**CITY OF MCMINNVILLE  
PLANNING DEPARTMENT**  
231 NE FIFTH STREET  
MCMINNVILLE, OR 97128

**DECISION, CONDITIONS, FINDINGS OF FACT AND CONCLUSIONARY FINDINGS FOR THE APPROVAL OF A LANDSCAPE PLAN AND STREET TREE PLAN FOR THE BAKER CREEK NORTH SUBDIVISION**

- DOCKET:** L 12-19 (Tree Removal, Landscape Plan and Street Tree Plan)
- REQUEST:** Approval of a Tree Removal, Landscape Plan and Street Tree Plan for the Baker Creek North subdivision.

Open Space 'Tract I':

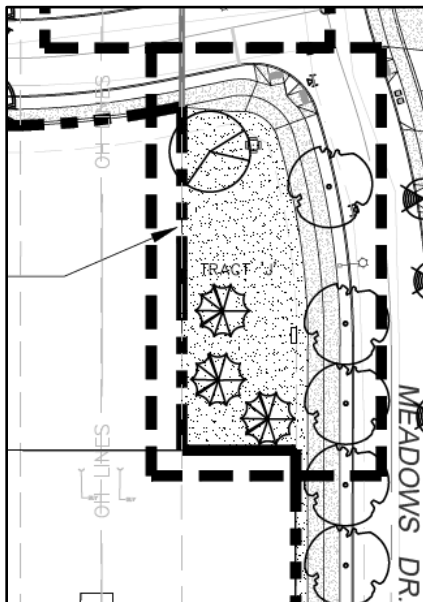
Based on comments from McMinnville Water & Light, trees surrounding the electric substation should be limited in height to 25 feet. A condition is included limiting the height of any trees located in Open Space Tract I to a maximum mature canopy height of 25 feet.

Open Space 'Tract K':

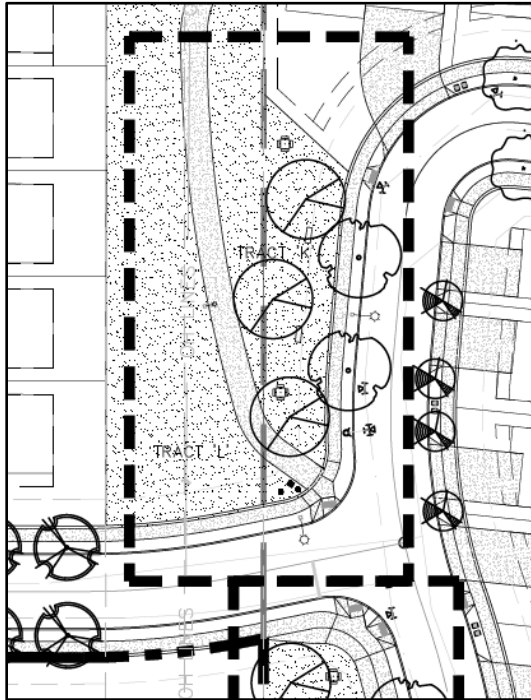
Sunburst Honey Locusts grow approximately 40 feet tall and wide. Based on comments from McMinnville Water & Light, trees in Tract K should be located such that no canopy encroaches into the transmission easement. A condition is included limiting the height of any trees in Open Space Tract K to a maximum mature canopy height of 40 feet and to locations such that no canopy encroaches into the transmission easement.

Open Space & Access Easement 'Tract L':

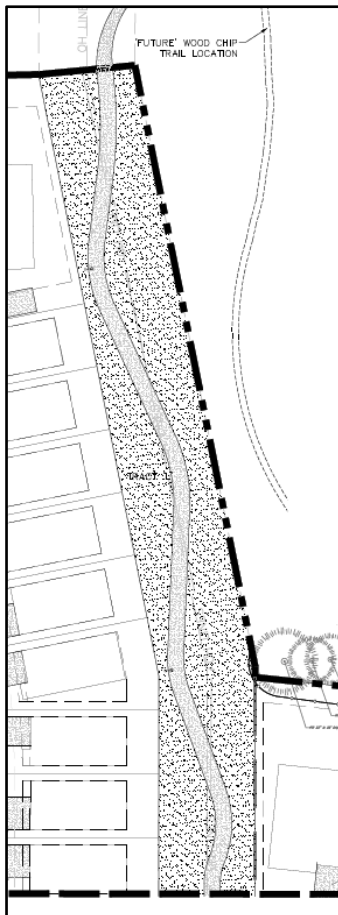
Additionally, no street trees should be located within the public right-of-way in the transmission line easement, where they would be in incompatible with electrical transmission lines overhead.

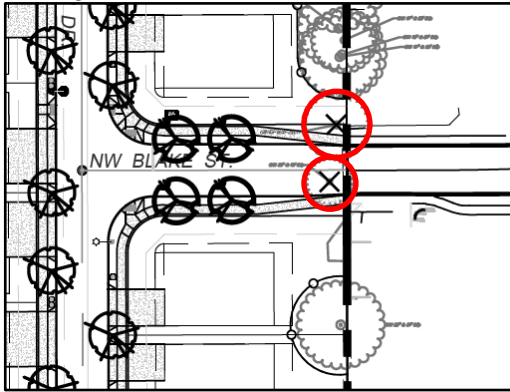
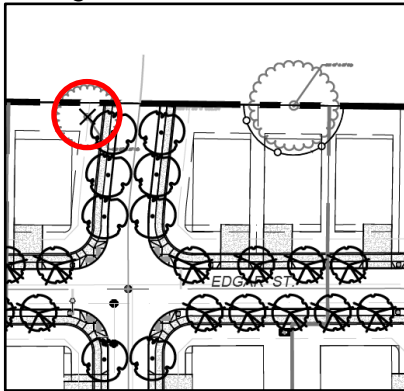
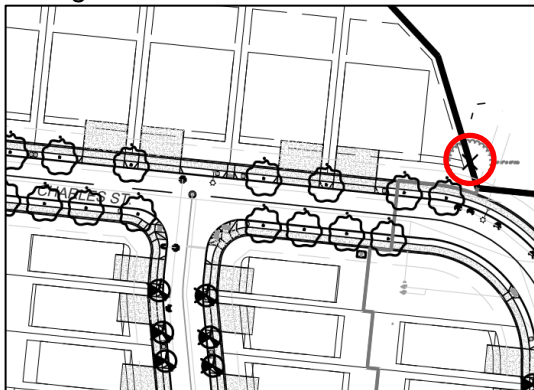
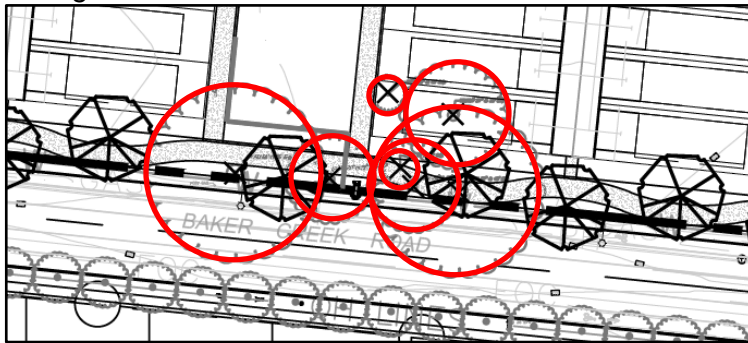
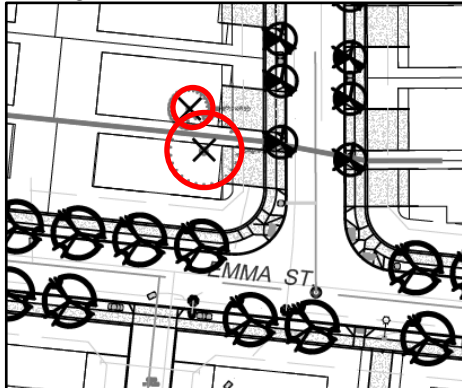
**FINDING: SATISFIED.** The City concurs with the applicant's finding's finding. Drawing L1.0 Street Tree Plan indicates that 17 trees are proposed for removal. The applicant has indicated the location, type, and size of the trees requested for removal on the Street Tree Plan, shown in more detail in Street Tree Plan Enlargements A-F and accompanying tree schedules below. The requested tree removals are not designated as exempt by the zoning ordinance, therefore the requested removals require City approval.

**CONDITION FOR FINDING:** That only the 17 trees identified for removal on Drawing L1.0 Street Tree Plan shall be approved for removal.
